**COMMISSION OF ARCHITECTURAL REVIEW  
STAFF REPORT  
March 27, 2018, Meeting**

17. **COA-031753-2018** (Dobrin Homes)

**617 West 21<sup>st</sup> Street  
Springhill Old and Historic District**

**Project Description:** **Construct a new single family dwelling.**

1950 Sanborn Map

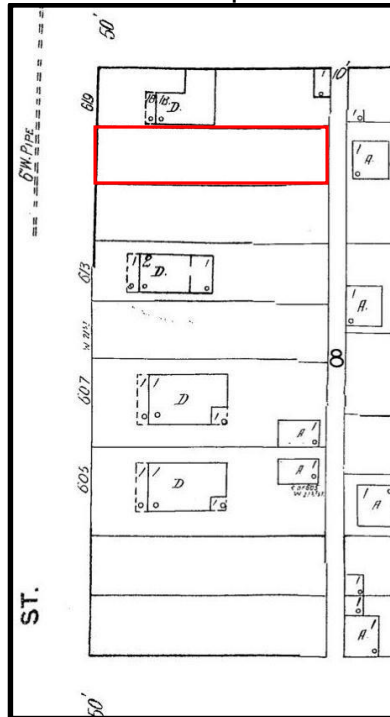
A context site plan was not provided. The historical pattern of the block is consistent with the setback pattern of the historic structures on the block as it appears half of the block including the subject lot was not developed.
